A G E N D A

Architectural Review Board

October 23, 2018

432 Cloverdale Road

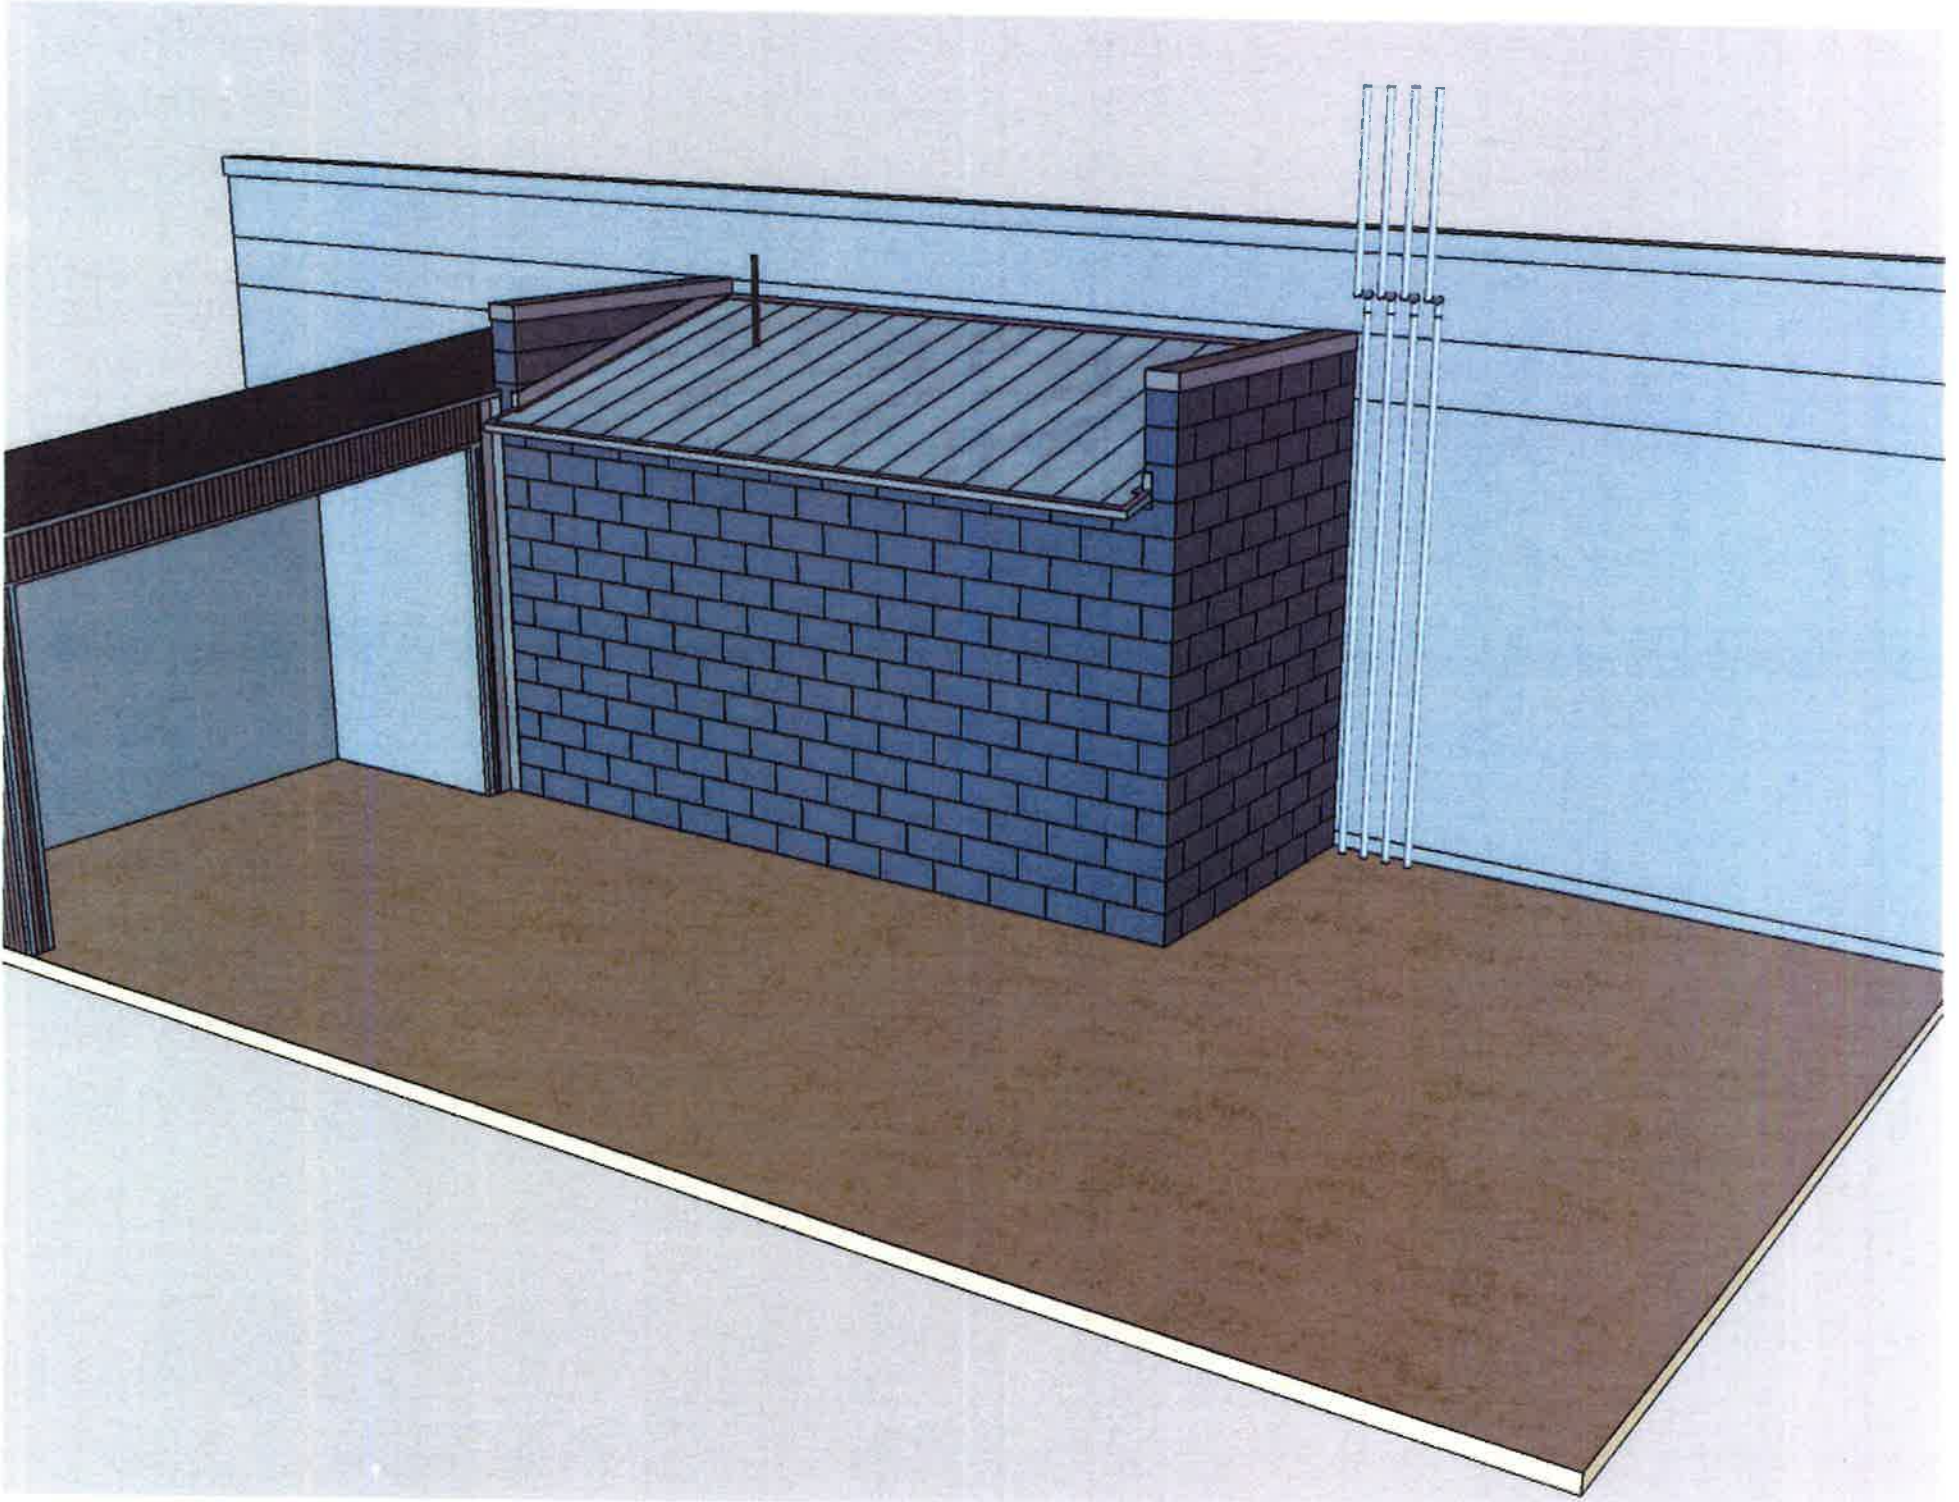
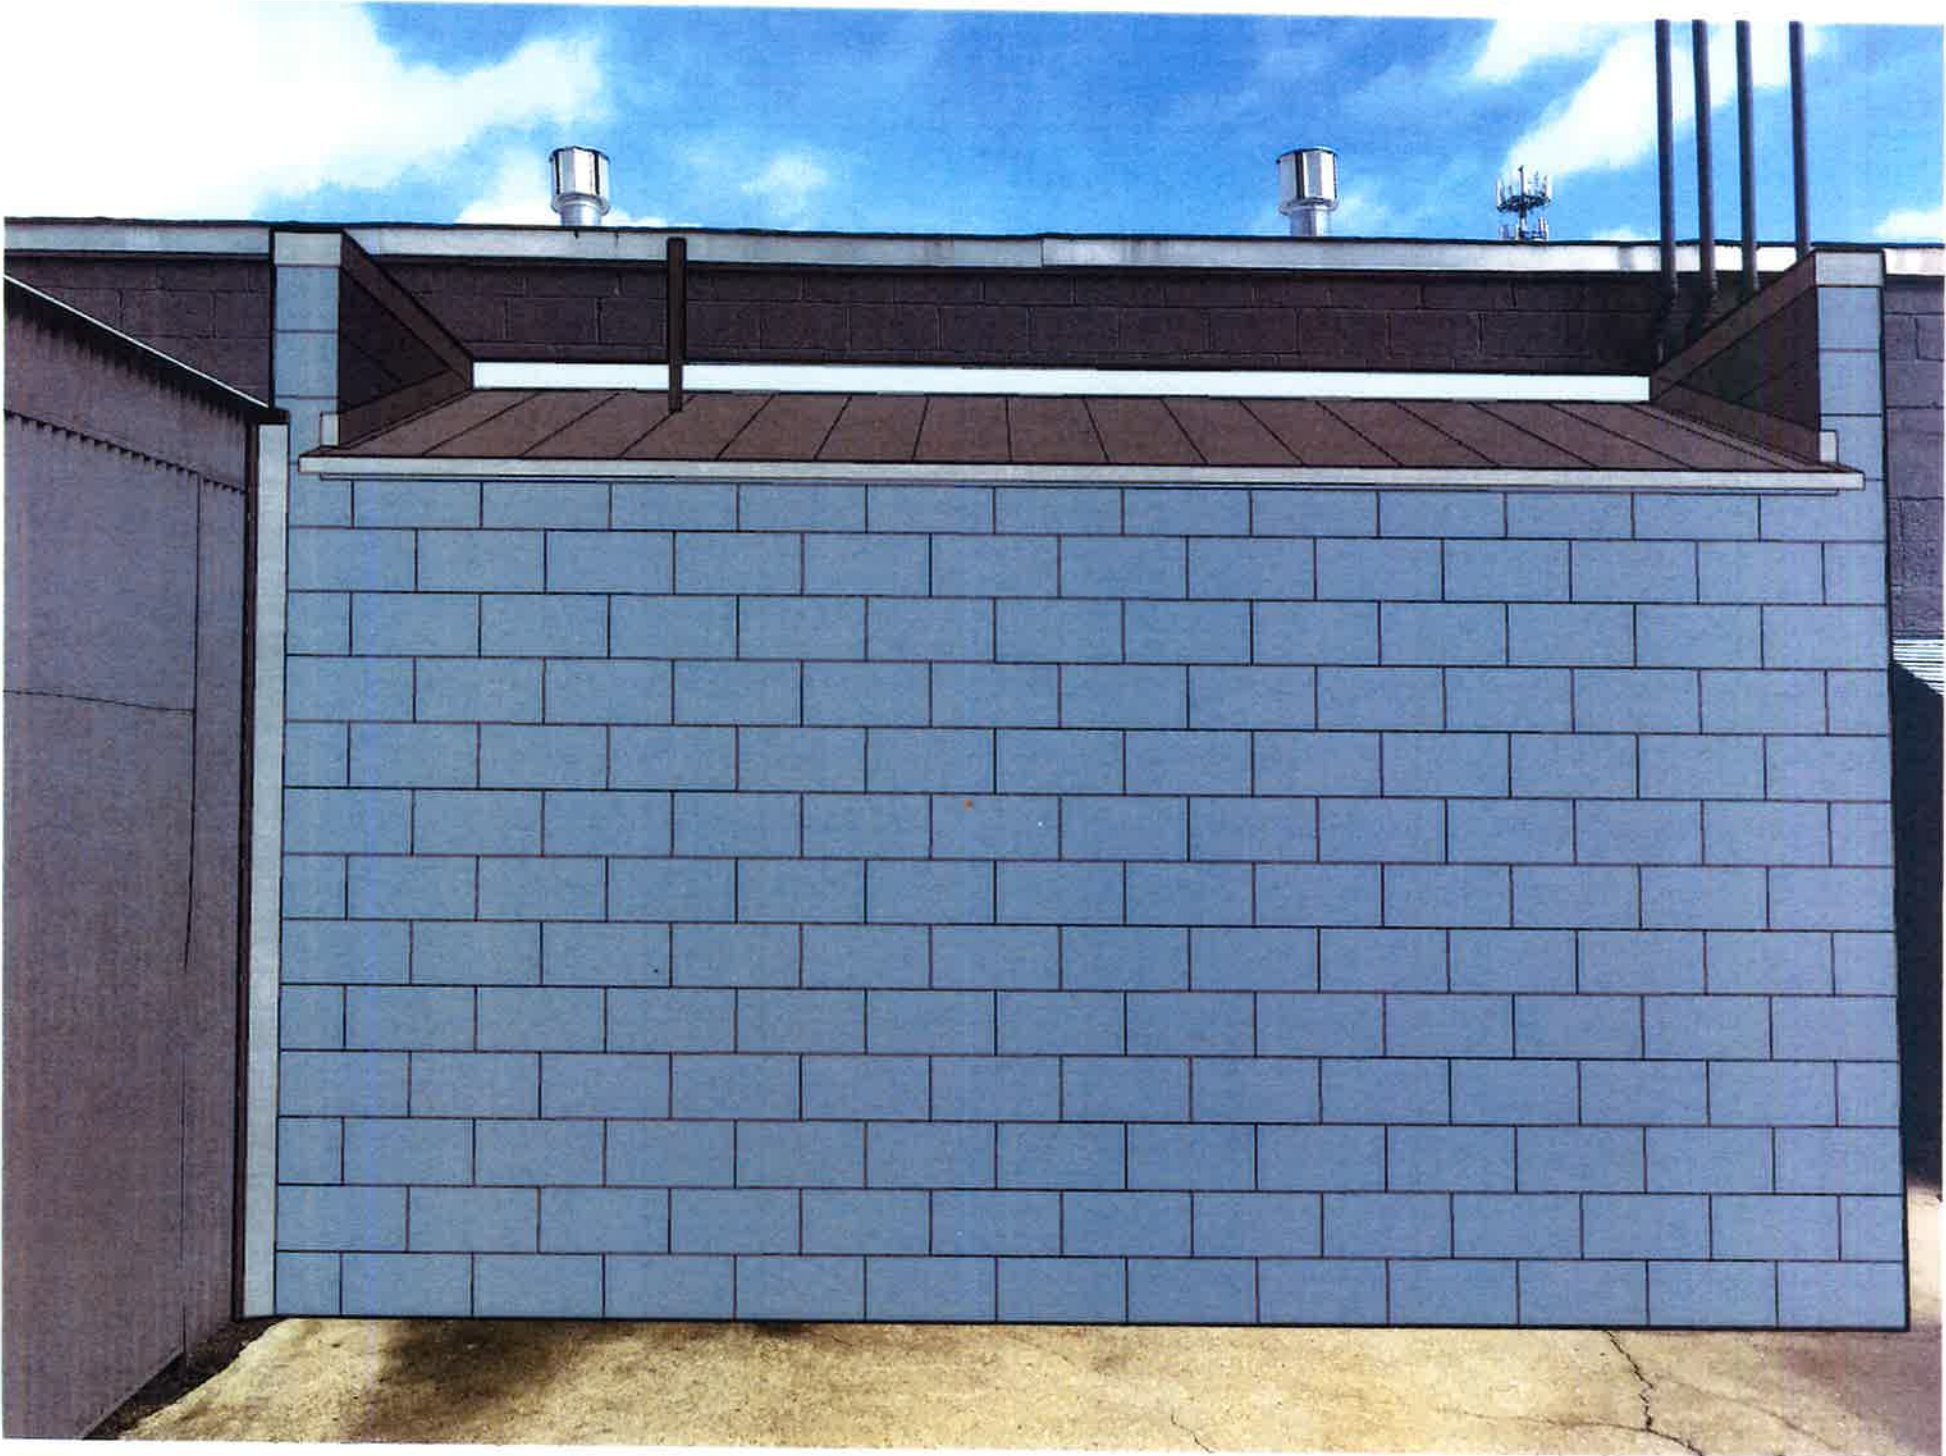
REMARKS: The petitioner is requesting permission an 8'x18' addition at the rear of the gas station for storage. Changes in the auto repair industry and service equipment requires more interior space than the current building affords. Addition will be constructed of concrete block to match the building, and painted to match. A metal shed roof is proposed that will be partially screened by a parapet wall on the end.

- Materials selected match existing. The addition will only be visible from Graham Street and not impact the primary façade.

939 Park Avenue

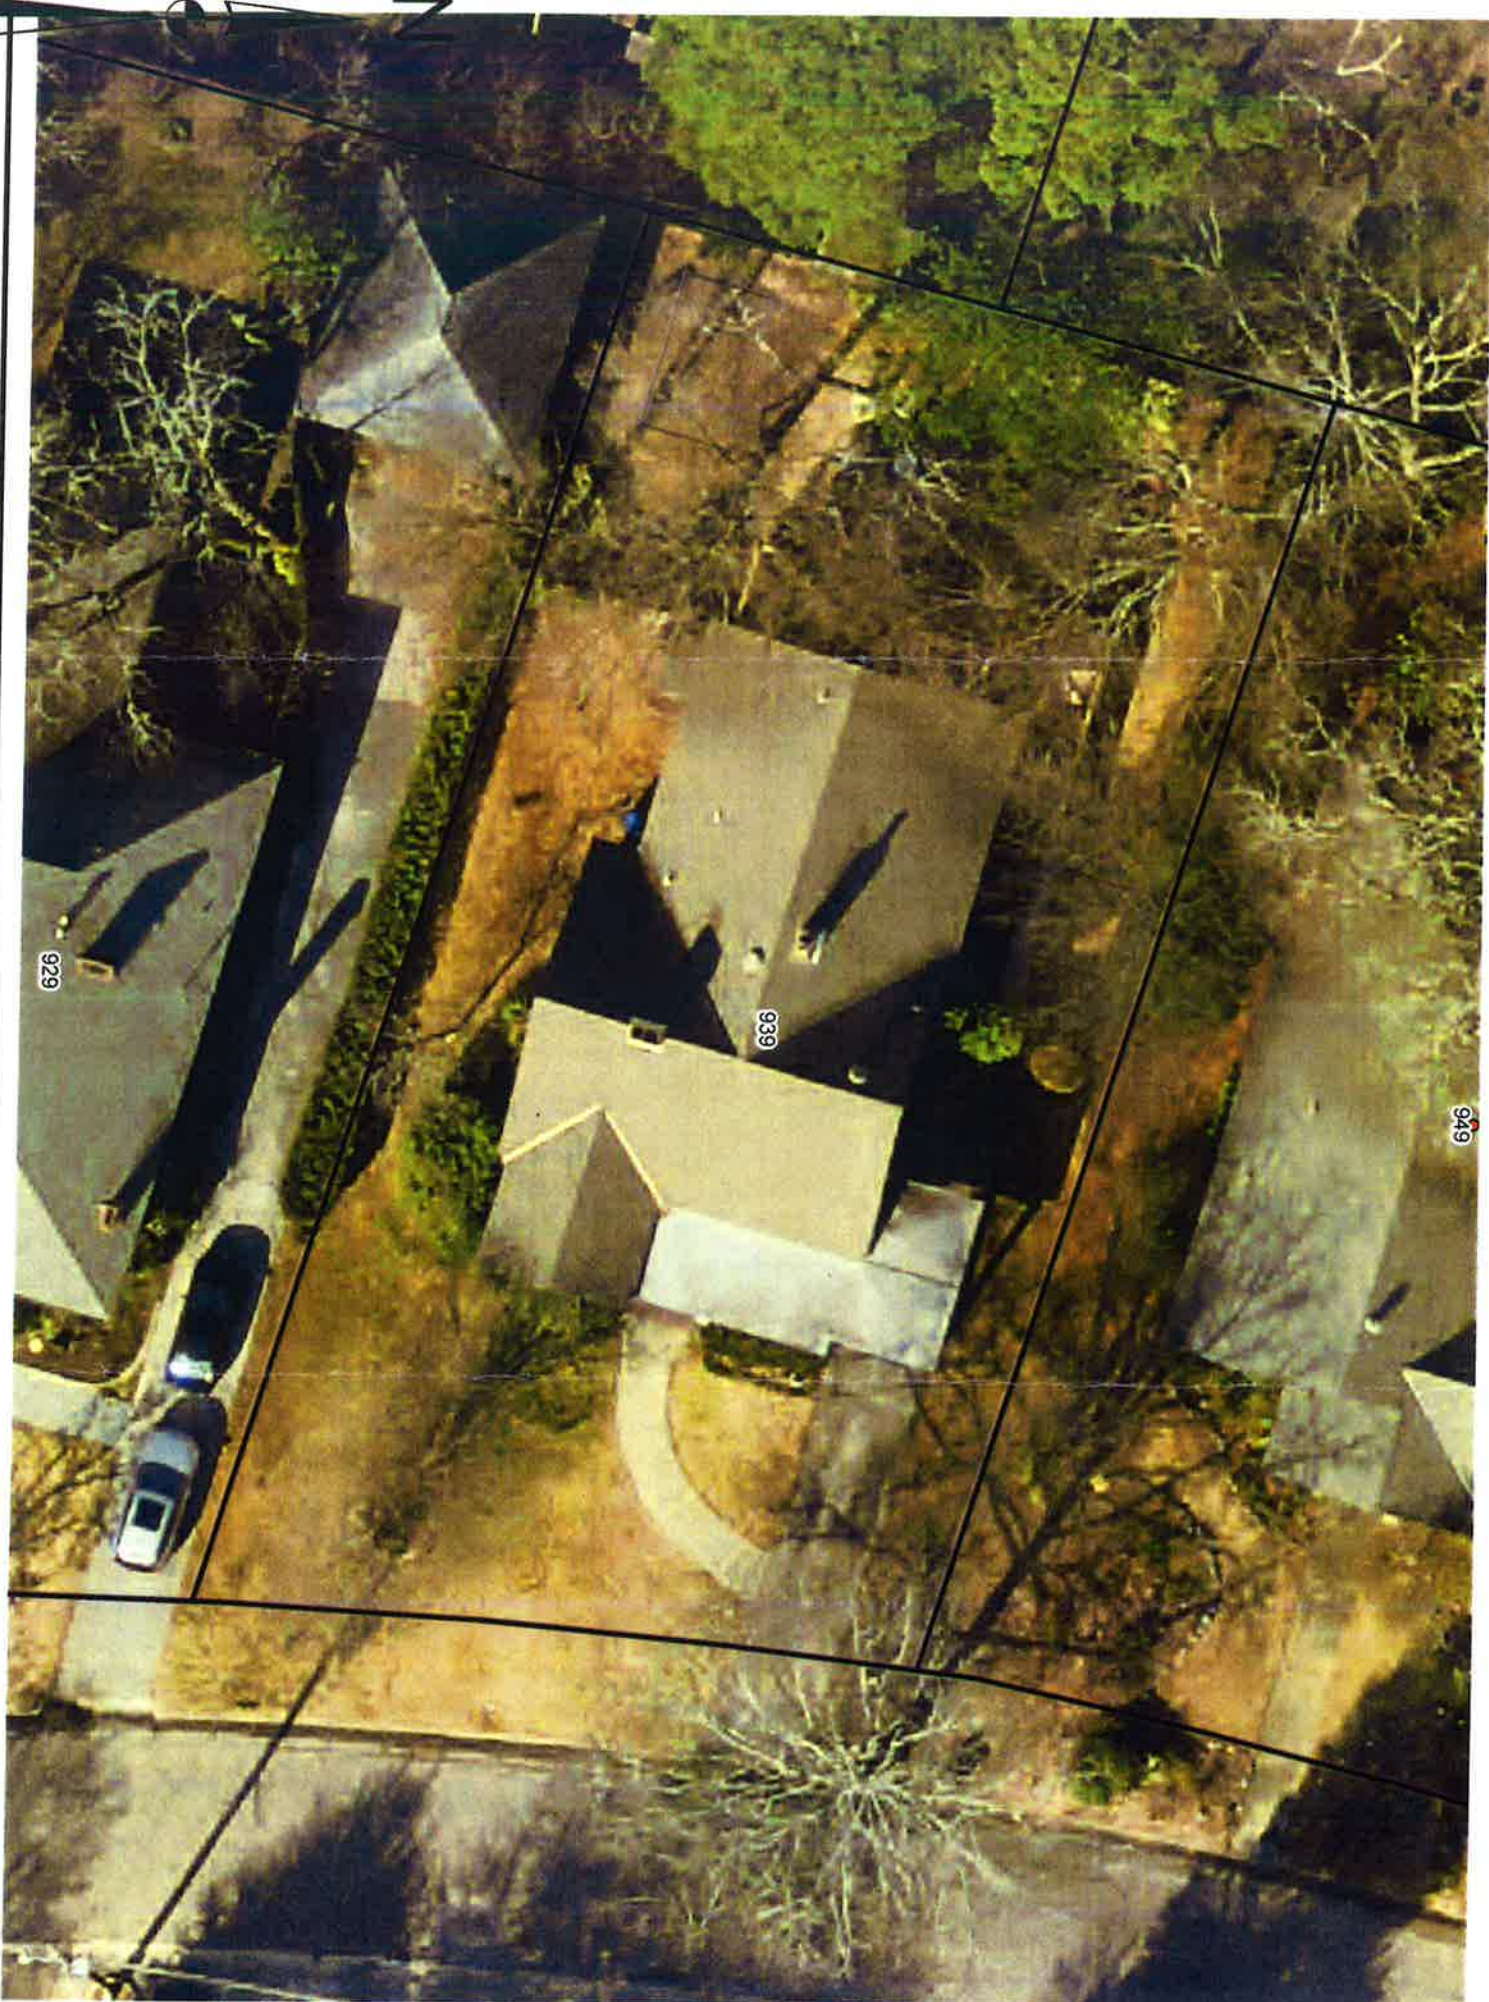
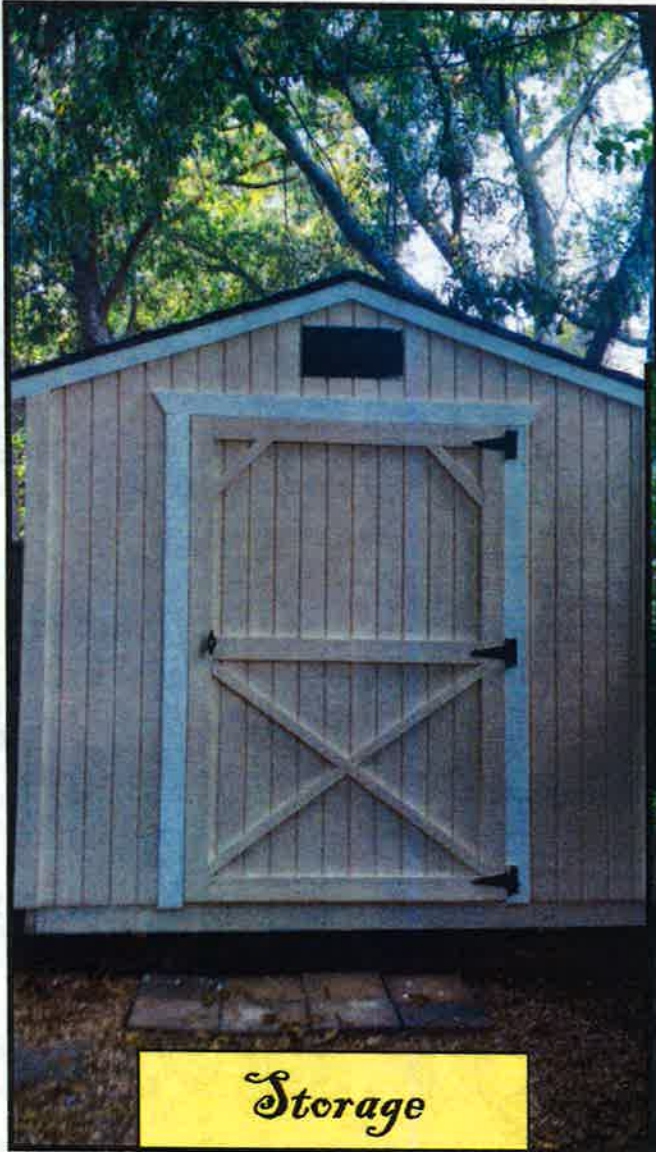
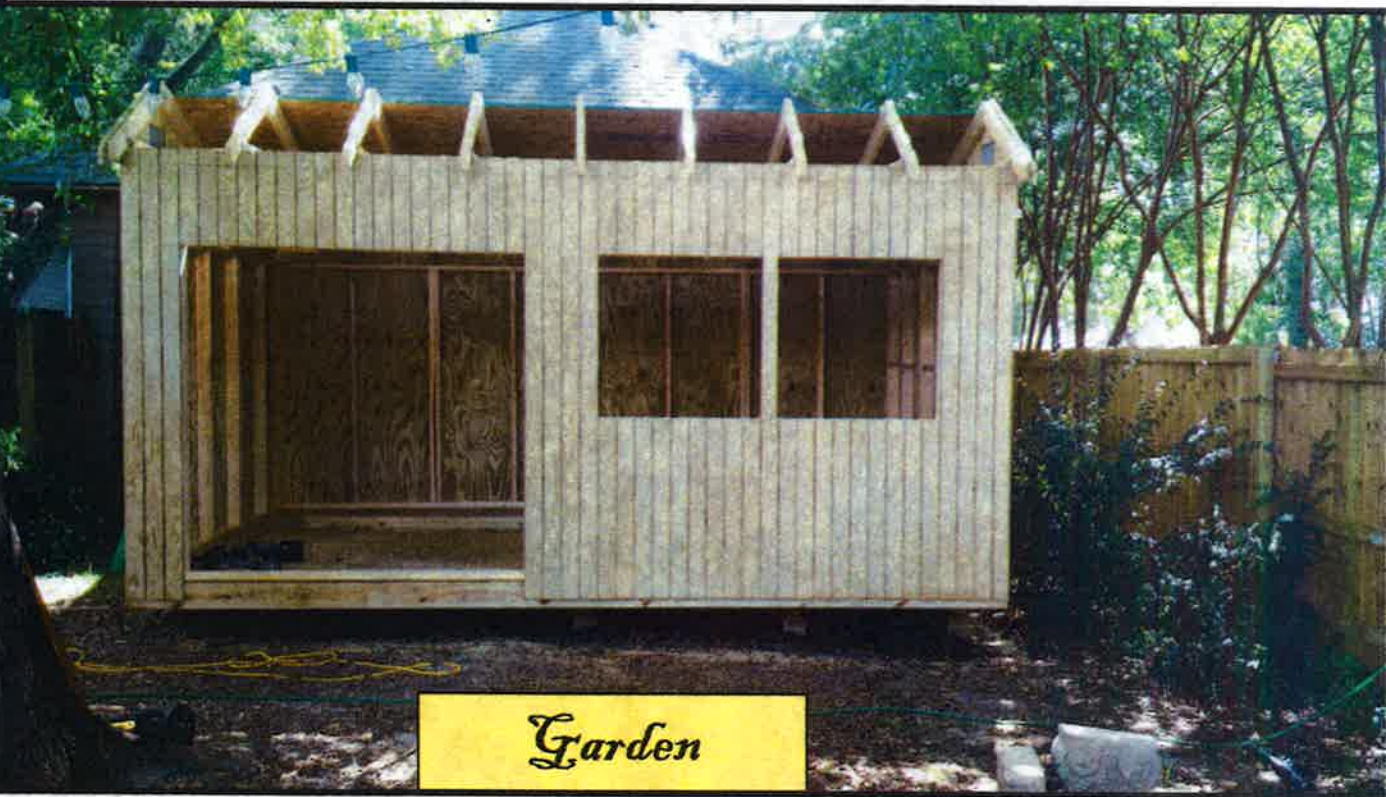
- The footprints of the two sheds combined is less than what the zoning for the property permits (R-75-d = 675 SF).
- The smaller shed is slightly visible from the street, it is screened by a porte cochere and fence. The second shed is not visible from the street.

- Accessory structures are to be compatible in materials and appearance to the main dwelling (generally that has meant horizontal lap siding and an overhanging eave). In this case, the main dwelling is brick, and while the Board has not asked owners of brick houses to build brick outbuildings, the Board needs to determine if the vertical grooved siding and style of the sheds are compatible.

- The Board needs to render a decision based on the question: “would we have approved this if he had asked for permission first?”
- While there is was an outbuilding on the property prior to the installation of the two sheds, the 1953 Sanborn maps indicate there was a garage at the end of the driveway in the rear corner of the yard.
